Access Compliance Report

Public Rights-of-Way

(Curb Ramps)

Intersection ID: 45985	Main Street: MASON_MILL_PL	Cross Street: WILLOW_VALLEY_CT	Location: NW
ADA ID: 9FDB6CF7DB03	Ramp Type: BlendTrans1	Initial Pass/Fail: Fail	Overall Compliance: No
Severity Score: 21.25			
Codes/Mitigation Info/Possible Solution		Field Measurements/Component Compliance

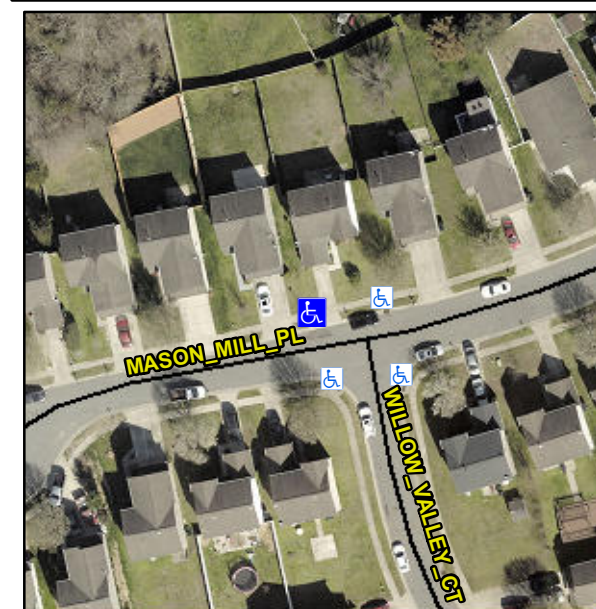
Not Found, R304.5.1, R304.5.3

Compliance	Description	Data	Compliance	Description	Data
N/A	Ramp Length (in)	48.0	Yes	BlendTrans Slope (%)	4.2
No	Ramp Width (in)	46.0	No	BlendTrans XSlope (%)	6.0
N/A	Flare Type LT	N/A	N/A	Flare Type RT	N/A
N/A	Flare Slope LT (%)	N/A	N/A	Flare Slope RT (%)	N/A
N/A	Flare Traversable LT?	N/A	N/A	Flare Traversable RT?	N/A
N/A	Landing Length (in)	N/A	N/A	DWS Provided?	N/A
N/A	Landing Width (in)	N/A	N/A	DWS Contrast?	N/A
N/A	Landing Slope (%)	N/A	N/A	DWS Length (in)	N/A
N/A	Landing X Slope (%)	N/A	N/A	DWS Full Width?	N/A
N/A	Landing Curb? (Y/N)	N/A	N/A	DWS Offset (in)	N/A
N/A	Shared Landing?	N/A			
N/A	Gutter Ponding?	N/A	N/A	Gutter Slope (%)	N/A
N/A	Gutter Lip Ht (in)	N/A	N/A	Gutter X Slope (%)	N/A
N/A	Painted X Walk1?	No	N/A	Painted X Walk2?	N/A
	X Walk 1 Direction	To S		X Walk 2 Direction	N/A
	X Walk 1 Width (in)	N/A		X Walk 2 Width (in)	N/A
	X Walk 1 Slope (%)	0.6		X Walk 2 Slope (%)	N/A
	X Walk 1 X Slope (%)	4.0		X Walk 2 X Slope (%)	N/A

N/A	Ramp inside XWalk1?	N/A	N/A	Ramp inside XWalk2?	N/A
	Road Slope (%)	4.0		Clear Space?	N/A
	Road X Slope (%)	0.6	N/A	Clear Space to XWalk (in)	N/A
N/A	Any Obstructions?	N/A	N/A	Storm Grate/Utility Hazard?	N/A
	Obstruction Type			Storm Grate/Utility Type	
		N/A			N/A
			Yes	Surface Condition? (G/P)	Good
			No	Curb Slope (%)	6.9

Remove & Replace Curb Ramp With Two New Directional Ramps or Equivalent.
